Westinghouse
Electric Corporation

SUBJECT: RESPONSES TO REQUESTS FOR ADDITIONAL INFORMATION ON THE
NOTRUPM FINAL VALIDATION REPORT

Question 440.599

Figure 440.610-4

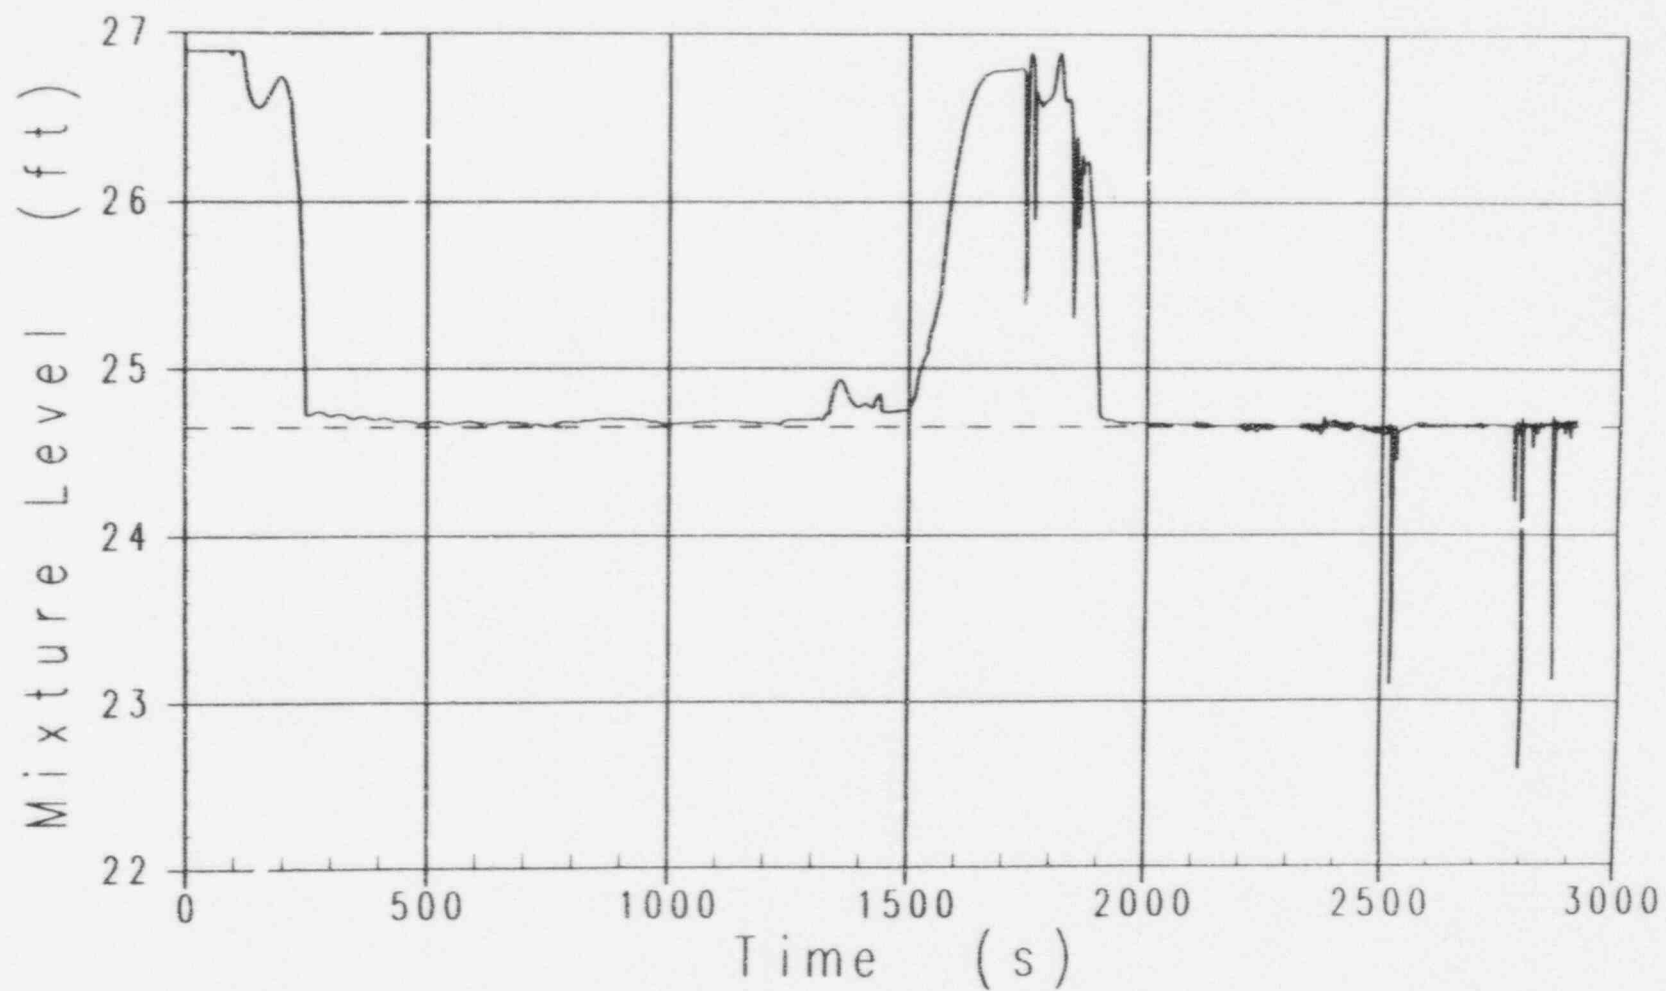
- a) The mixture level in the pressurizer increases to the top of the pressurizer (Figure 440.610-5). The core average void fraction (Figure 7.3.1-17) and upper plenum (Figure 440.610-4) both drop to zero, same as in the test. The pressurizer fills to about 50 lbm.

- a) At about 1800 seconds, vapor is once again generated in the core, causing the upper plenum void fraction to increase (Figure 440.610-1).
- b) The void fraction in the hot leg begins to increase (Figure 440.610-6), consistent with the increase in the upper plenum void fraction, which is similar to the collapsed level decrease in the test (Figure 3.2-64).
- c) Liquid continues to flow into the surge line (Figure 440.610-7). Therefore, CCFL conditions are also predicted by NOTRUMP during this time.

Figure 440.610-5

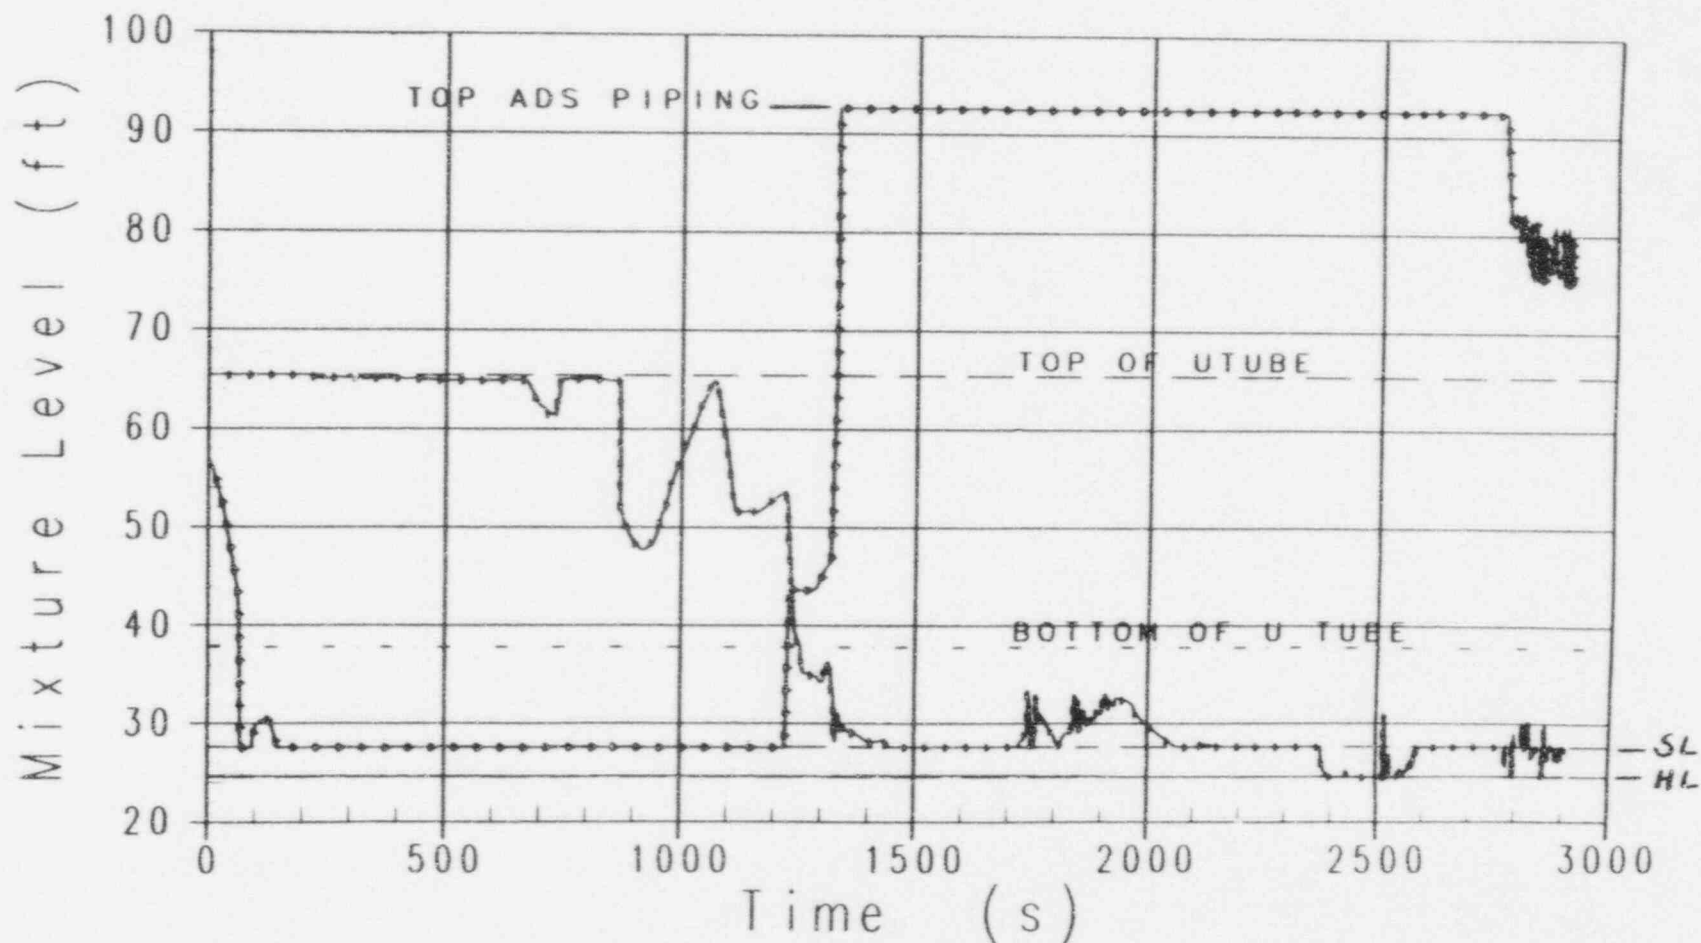
- a) The pressure is about 700 psia (Figure 7.3.1-2), the pressurizer is empty (Figure 7.3.1-3), and the CMTs are draining (Figures 7.3.1-4,5).
- b) The core average void fraction is about 20 percent (Figure 7.3.1-17) and in the upper plenum it is about 30 percent (Figure 440.610-1). Since the ADS valves open later, the void fractions are slightly lower than the data. The upper plenum void fraction is about 30 percent (Figure 440.610-1), and the mixture level is at the hot leg elevation (Figure 440.610-5).

- c) The mixture level in the steam generator tubes is about 16 feet relative to the bottom of the tubes (Figure 440.610-5). The void fraction in the region of the hot leg connected to the surge line (fluid node 11 in Figure 7.2-2, Reference 440.610-1) is about 40 percent (Figure 440.610-6). There is therefore less mass above the surge line inlet in the prediction than in the test (about 60 lbm compared to []^{a,b,c} lbm).

- b) The mixture level in the steam generator tubes and hot leg falls to the surge line inlet elevation at about 1300 seconds (Figure 440.610-5).
- c) During the short period when the mixture level is above the surge line (from 1220 to about 1300 seconds), the pressurizer mixture void fraction follows that of the mixture in the hot leg (Figure 440.610-6). When the hot leg mixture level falls below the surge line, the pressurizer void fraction increases because the steam flow into the surge line increases. Figures 440.610-7 and 8 plot the liquid and vapor flows into the pressurizer surge line (78) and at the top of the inclined hot leg (211). Figure 440.610-7 shows that the liquid flow from the regions above the surge line (SG tubes and inlet plenum) is zero (flow link 211) after about 1300 seconds, indicating that there is not much liquid stored above the surge line in the NOTRUMP prediction. Figure 440.610-8 shows that there is always vapor flow into the surge line in the NOTRUMP prediction. Unlike the test, therefore, the flow into the pressurizer is not all water during the level swell phase.

Figure 440.610-6

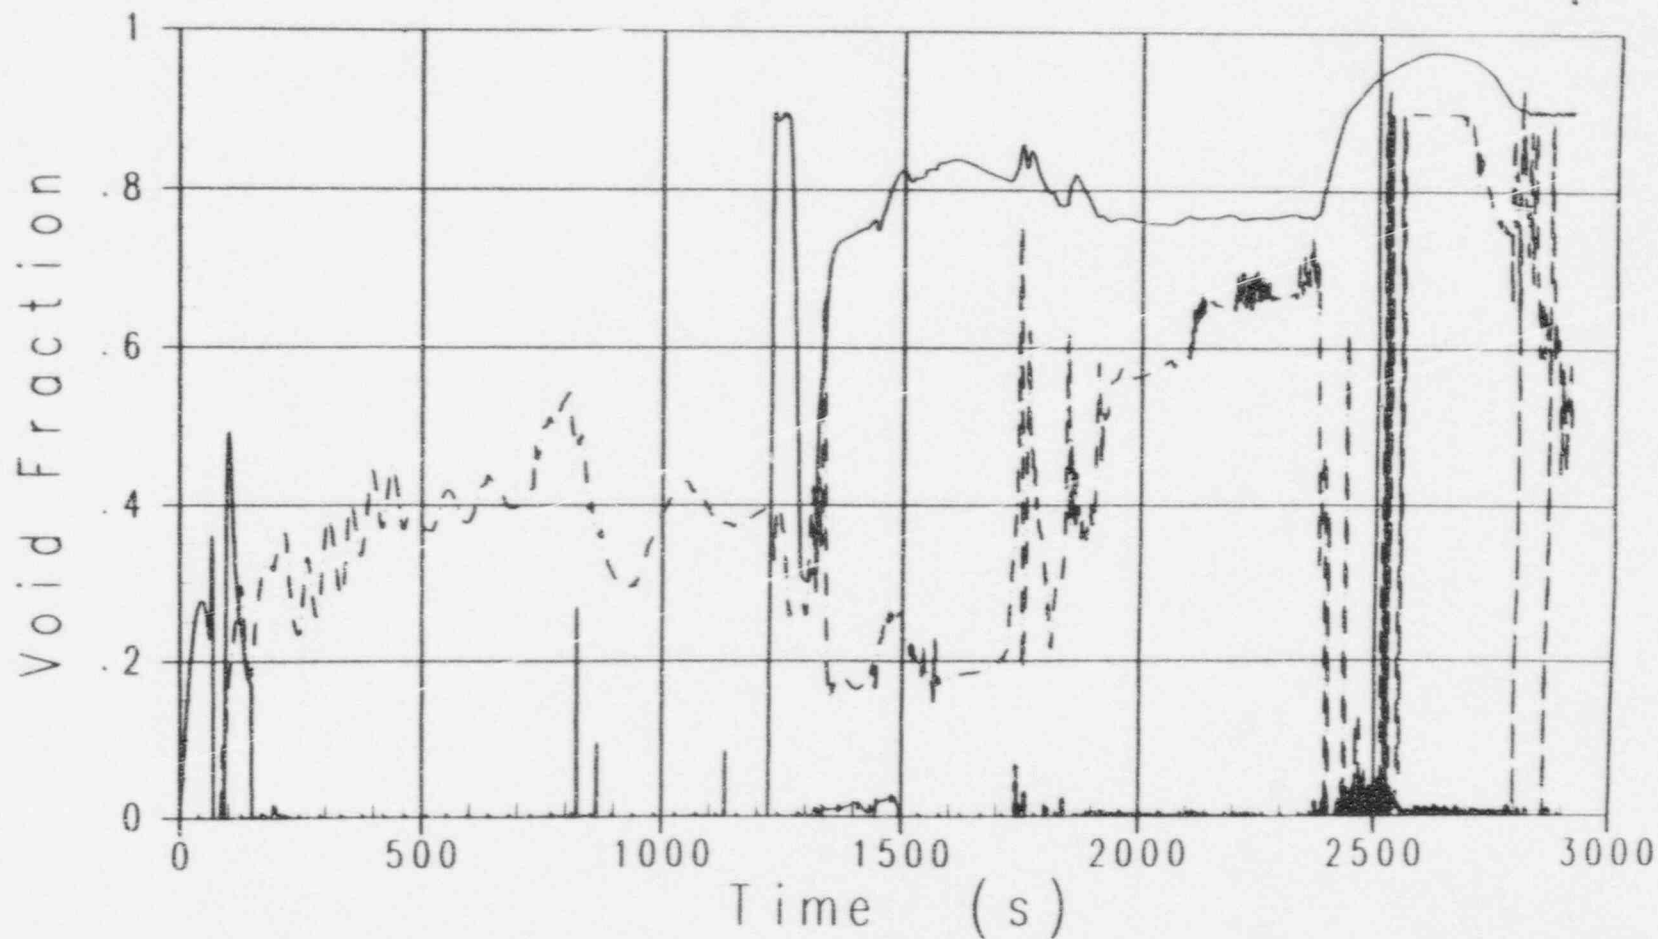
- d) The void fraction in the mixture in the pressurizer is about 80 percent (Figure 440.610-6). Since there is only one fluid node, a void fraction distribution is not predicted. Figures 440.610-9 and 10 plot the inlet and outlet vapor and liquid flows in the pressurizer. NOTRUMP also predicts a higher vapor outflow due to the release of energy from the metal and flashing of the mixture. The liquid flows indicate that as much liquid is flowing out as is flowing in. The mass which can be stored in the pressurizer is therefore controlled by the void fraction predicted by the drift flux model for the given vapor flow which based on the previous discussion, is higher than in the test.

Figure 440.610-17

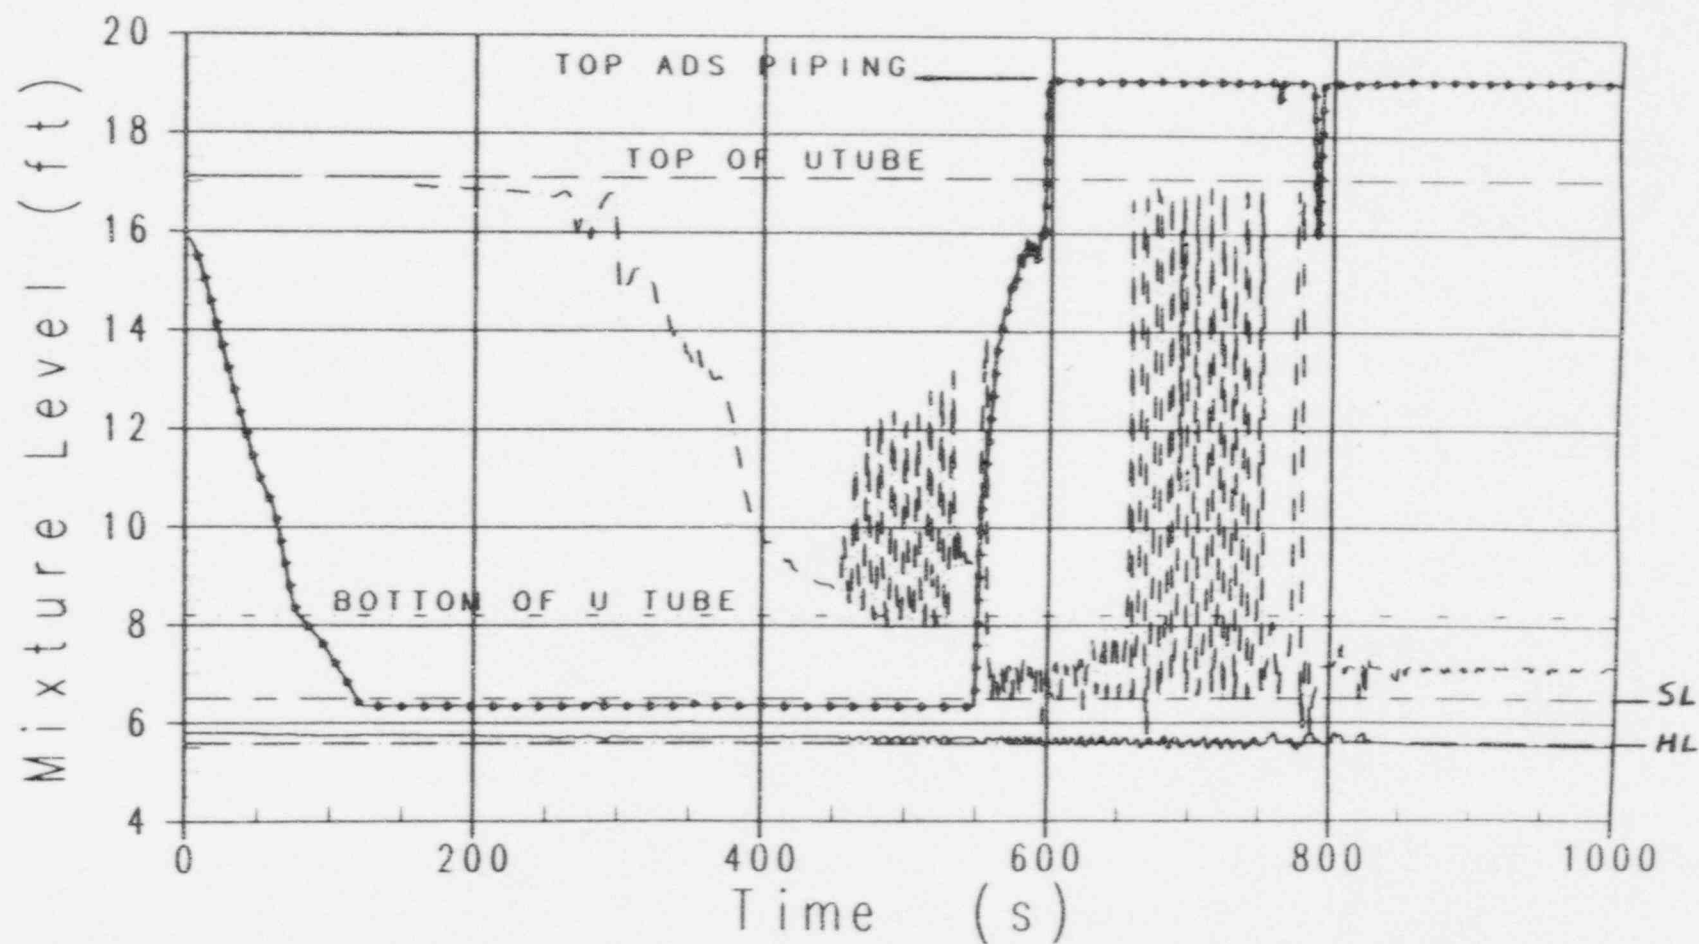
- c) At the time that ADS is actuated, the tubes have fully drained (Figure 440.610-17), the steam generator inlet plenum has partially drained with about 14 lbm remaining in steam generator 2 (on the PRHR loop). The hot legs are full (Figure 440.610-17).

- a) The pressurizer and surge line refill to about 290 lbm. The level in the inclined portion of the hot leg drops to the surge line elevation, and the mixture level reaches the top of the pressurizer (Figure 440.610-17). The collapsed liquid level fills the core region (Figure 8.3.1-14), but vapor generation in the core is not fully suppressed (Figure 440.610-21). Consequently, vapor is still available to flow into the pressurizer.

- b) At about 650 seconds, the mixture level in the steam generator rises into the tubes, then begins to oscillate (Figure 440.610-17). This oscillation is driven by steam generation in the tubes, which are now hot due to primary depressurization (Figure 440.610-18). This steam generation pressurizes the system, pushing steam and water into the pressurizer. As the level drops out of the tubes, the steam generation is reduced, the system pressure drops, and both steam and liquid flow out of the pressurizer (Figures 440.610-19 and 20). This behavior persists until about 800 seconds, and contributes to additional vapor flowing into the pressurizer, and less liquid accumulation.

The mixture level in steam generator 2 (SG-2) rises into the tubes on the hot leg side at about 650 seconds as discussed in the response to RAI 440.610 (see Figure 440.610-17). This causes reverse heat transfer in the secondary side and a corresponding drop in the secondary side temperature, seen in Figure 8.3.1-38. The later drop in the temperatures for both SGs (between 2150 and 2200 seconds) occurs following IRWST injection, when there is a second rise in the mixture level in the SG tubes. This is shown on Figure 440.610-22 for SG-2. A similar level rise is also predicted in SG-1 at the same time.

Figure 440.610-20

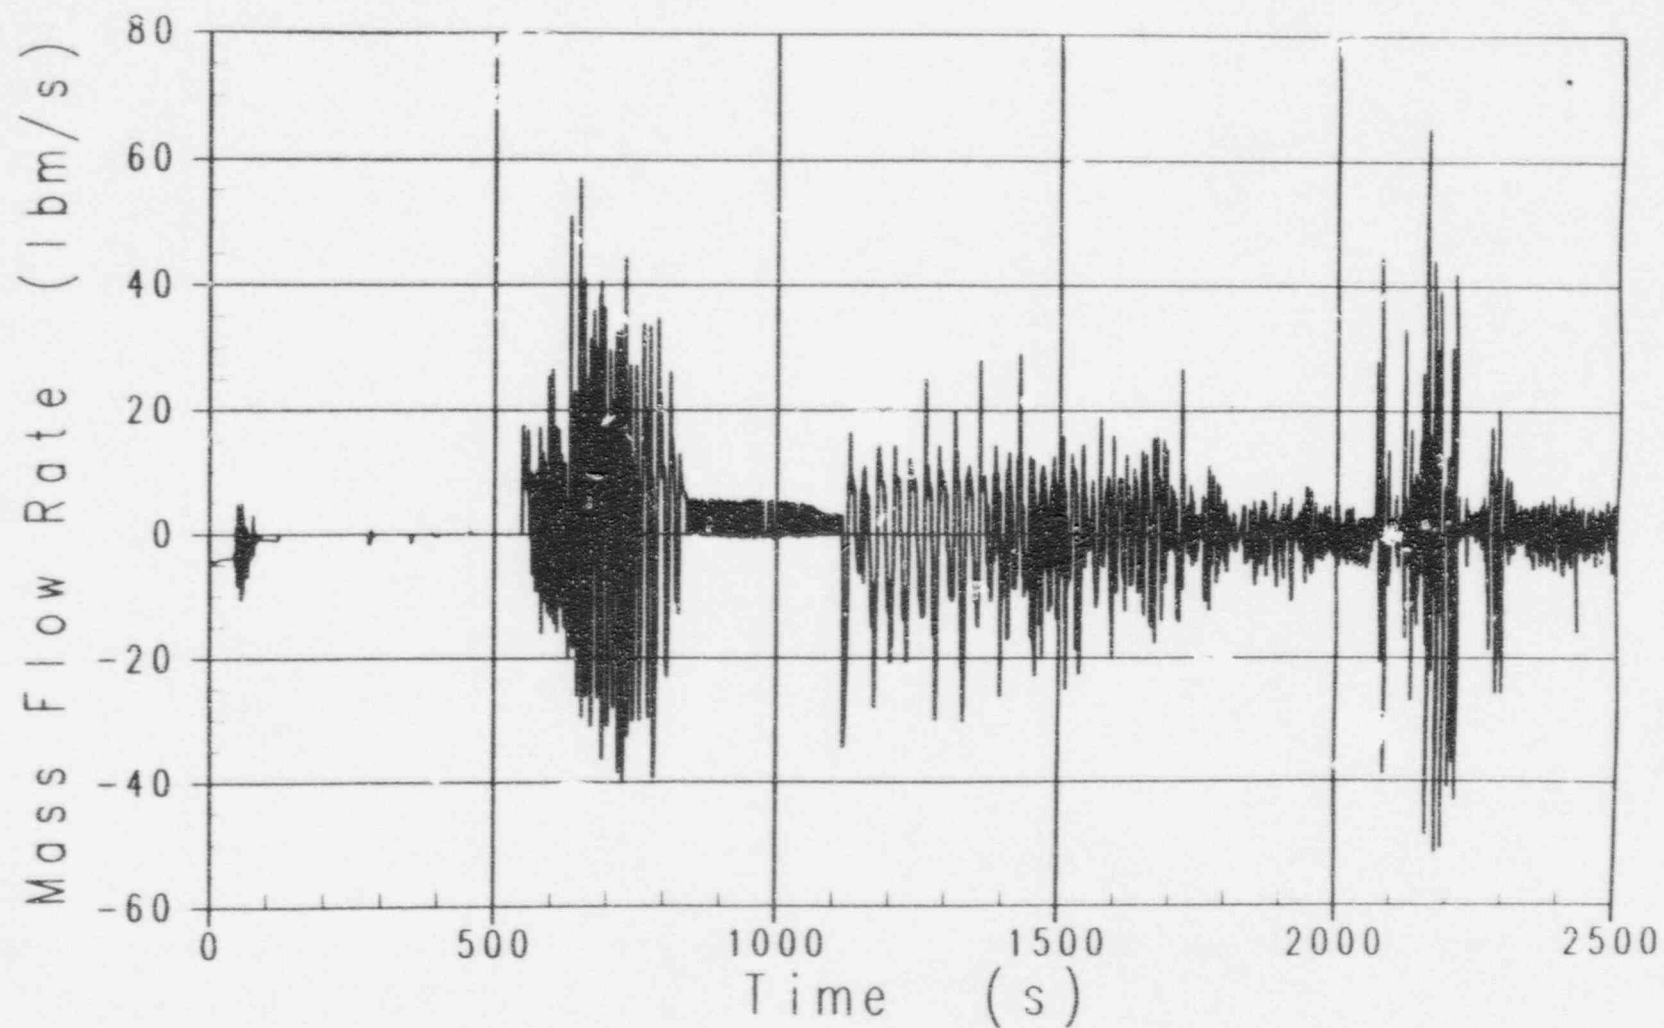
From 800 seconds until ADS 4 opens at 1100 seconds, sufficient vapor generated in the core (Figure 440.610-21) flows into the pressurizer to prevent water from draining (no liquid downflow in Figure 440.610-20).
